MONTGOMERY COUNTY HISTORIC PRESERVATION COMMISSION STAFF REPORT

Address: 3820 Warner St., Kensington Meeting Date: 11/17/2021

Case No.: 971756 Staff: Dan Bruechert

PROPOSAL: Partial Demolition, Building Addition, and Rear Deck

Majestic Niagara Slate

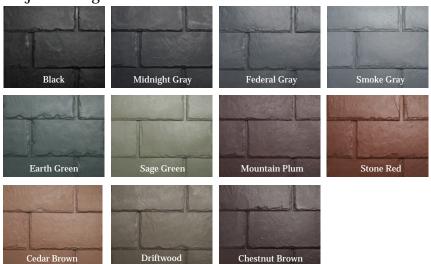
Staff finds that while synthetic slate roofs have significantly improved over the last few decades, they are still not a compatible roofing material on historic houses in the Kensington Historic District. Synthetic slates generally have reflective qualities that make them look like rubber or plastic and the 'slates' do not weather like natural slate. Staff does not recommend the HPC approve the proposed roofing material. Staff has relayed this finding to the applicant and they are consulting with their roofing contractor and their insurance company to identify a material that may be acceptable to all parties. In the meantime, Staff considers the appropriateness of several alternate materials and has provided a recommendation that Staff hopes is agreeable to the HPC.

The list of roofing materials that are not recommended is shorter than the list for materials that are. As is typical for Master Plan sites and districts in Montgomery County, Staff finds that synthetic slates and synthetic shakes are not appropriate for the house. In both cases, the material does not have an appearance that is consistent with the historic and the nature of the material prevents it from developing a patina, allowing it to blend in with the surrounding historic district.

1. The approval extends to the materials identified in the 'Recommended' section of the Staff Report with final approval authority delegated to staff to verify that the final material falls into one of those categories;
